AGENDA **HISTORIC RESOURCES BOARD**

CITY OF SAN JUAN BAUTISTA HISTORIC RESOURCES BOARD STAFF REPORT

AGENDA TITLE: Major Site and Design Review Permit: Renovation of stucco bungalow; 903 Third Street; APN 002-290-041 (Rich Holdaway for Rakesh Argawal)

Figure 1: 903 Third Street prior to construction

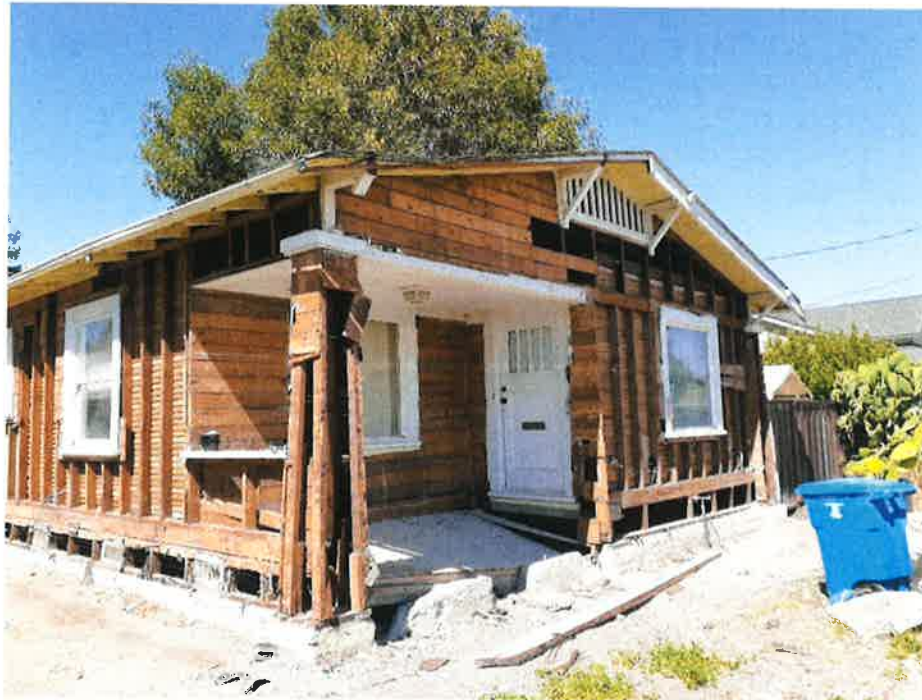
In 2022 construction started on a 628 square foot rear addition. During construction it was discovered that sections of the wood structural system which rested on the concrete foundation had deteriorated beyond repair. The original stucco exterior wall cladding started to peel away from the building. In addition, the front porch fell in and the original concrete stairs to the porch were destroyed.

as physical evidence to reproduce porch steps for 903 Third Street. Any of the eighteen District contributors can provide the physical evidence for the replacement of the exterior stucco finish for 903 Third Street. Preservation Brief 22⁶ advises:
